# PLANNING DIVISION STAFF REPORT

May 18, 2015

**Project Address:** 2121 North Stoughton Road (District 17 - Ald. Baldeh)  
**Application Type:** Conditional Use  
**Legistar File ID #** [38018](#)  
**Prepared By:** Kevin Firchow, AICP, Planning Division  
Report includes comments from other City agencies, as noted.

**Requested Action:** Approval of a conditional use to allow limited production and processing and outdoor storage in an existing commercial building in CC (Commercial Center) Zoning.

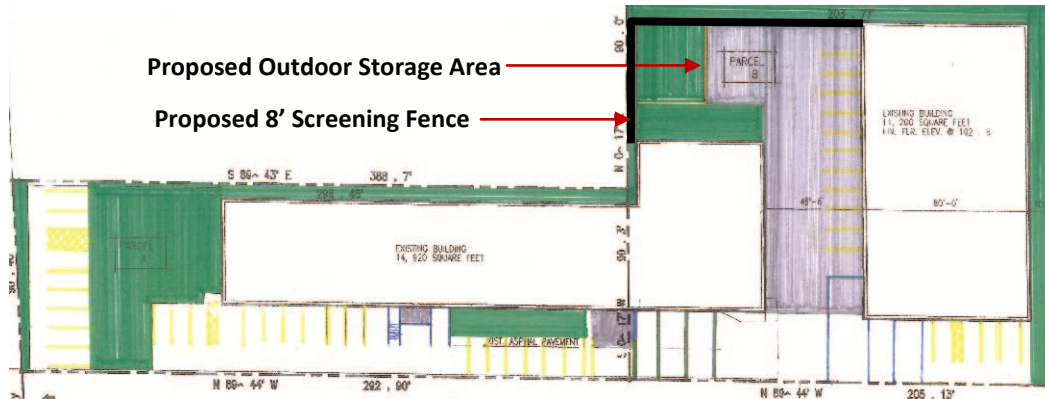
The second conditional use request is to establish a small, fenced storage area between the two subject buildings. An excerpt from the submitted site plan is below:

The letter of intent states that the storage area will be enclosed with an eight foot tall fence. The adjacent loading zoning will be reconfigured and converted from gravel to concrete. Such details should be clearly defined in the plans submitted for final sign-off.

1. That the site plan submitted for final sign-off clearly labels the location of the screening fence and pavement type (including areas of gravel or concrete). Other improvements described in the letter of intent including the retaining wall and loading zones should also be clearly depicted and drawn to scale for final review by City Agencies.

- 12. Insufficient dimensions to properly review this plan; it appears the parking adjacent North Stoughton Road does not have an adequate backup / drive aisle. The applicant shall revise the plan to demonstrate MGO 10.08 compliant parking dimensions or remove the parking.
- 13. The applicant shall be responsible for securing all proper permits and approvals from any municipality or government unit having jurisdiction with the project. In particular, the applicant shall contact David Kreitzmann, Wisconsin Department of Transportation (608-516-6497), with site plans sets for review and approval. The applicant shall return a set of site plans or letter with WDOT-approved copies to the City of Madison Traffic Engineering Division.

- 20. Provide information of existing tenants in building, so parking, bike parking and loading requirements may be calculated.
- 21. Clearly identify the outdoor storage area and associated screening on the final site plan. Note: Outdoor storage shall comply with supplemental regulations per Sec 28.151.
